DEVELOPMENT REVIEW COMMITTEE (DRC) COMMENT REPORT

PROJECT NAME: 4 Rivers Self-Storage

CASE NUMBER: UDP-S23050

REQUEST: Site Plan Level II Review: 150,140 Square-Foot Self-Storage Facility

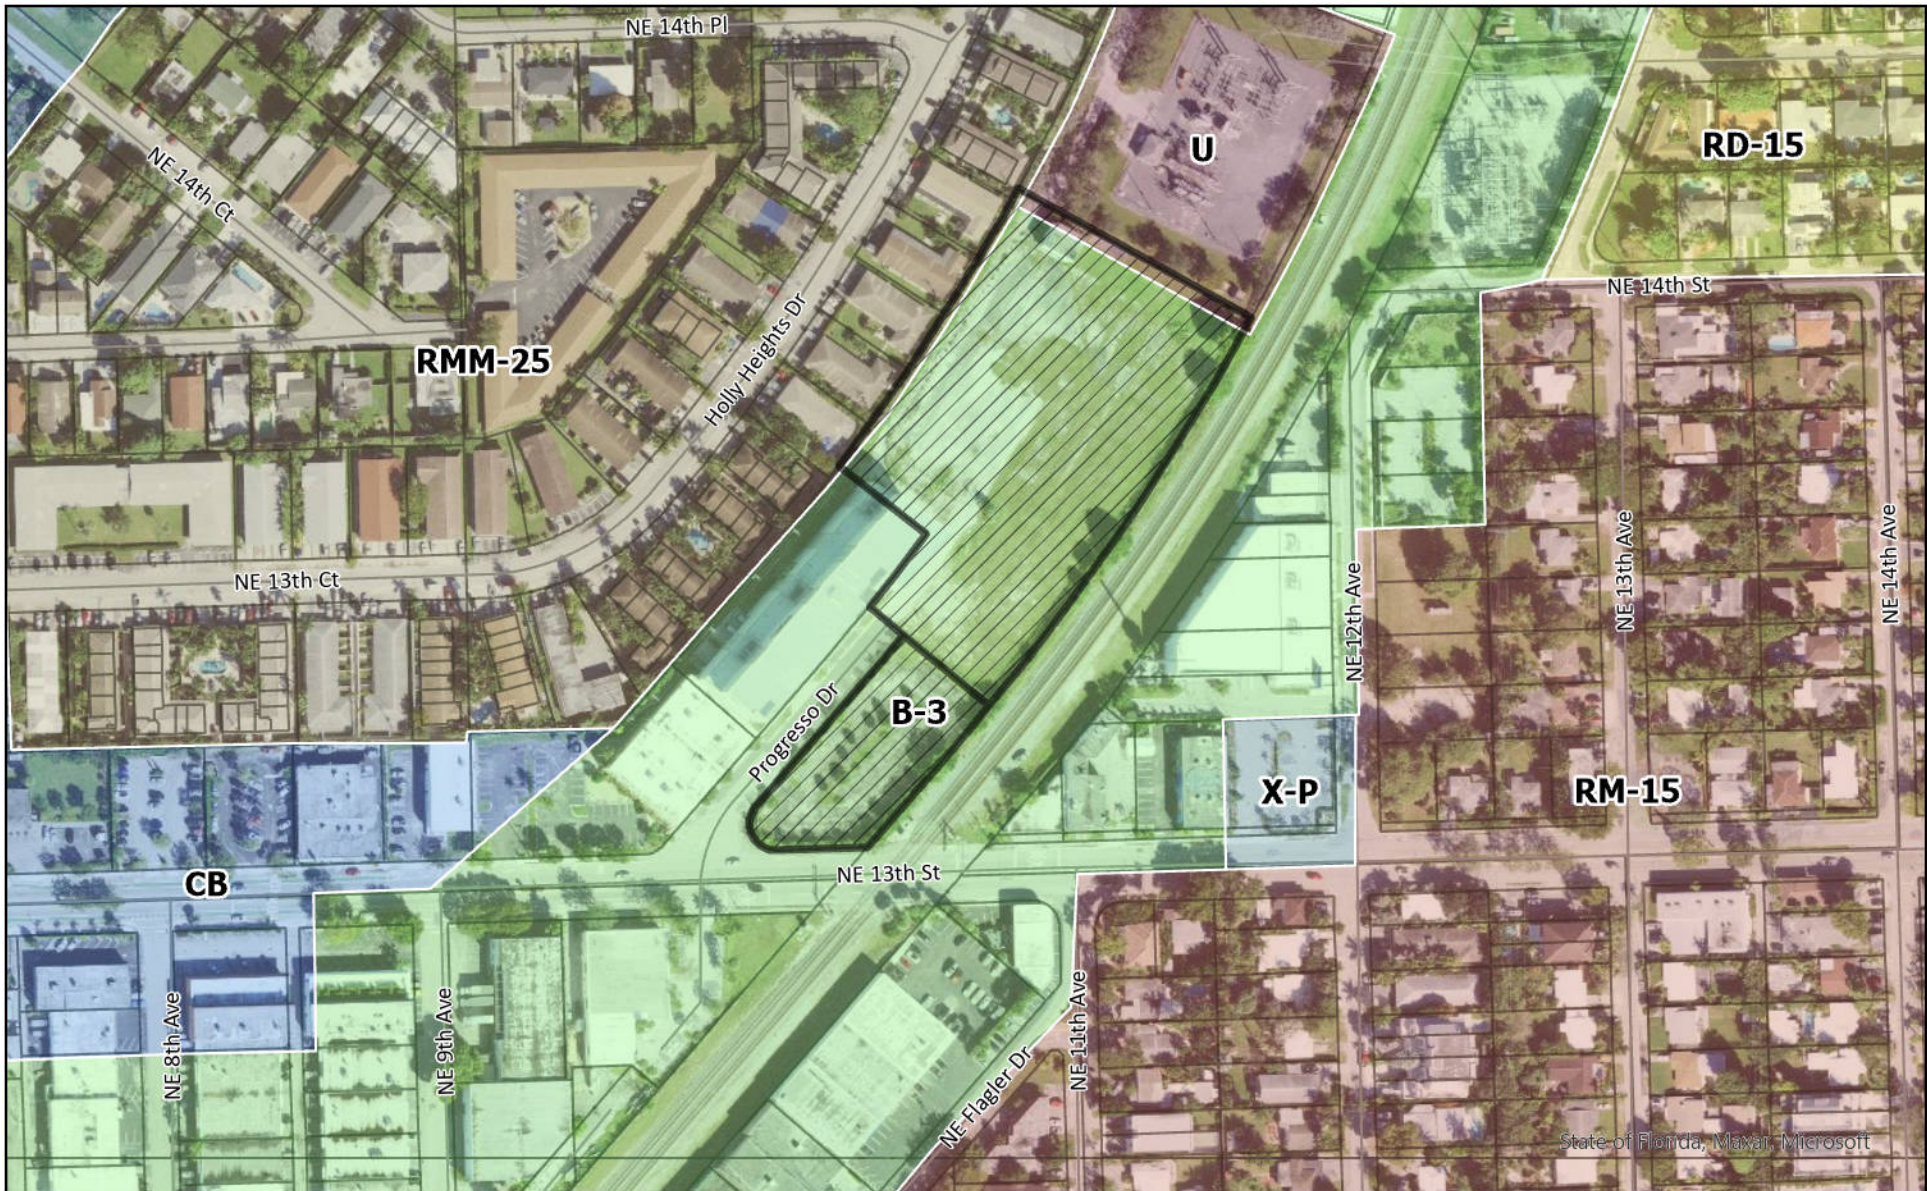
8. Provide the following changes on the site plan:
 - a. Provide an overall illustrative site plan that clearly depicts the property with the site boundaries, setbacks, and proposed changes. See example image below.
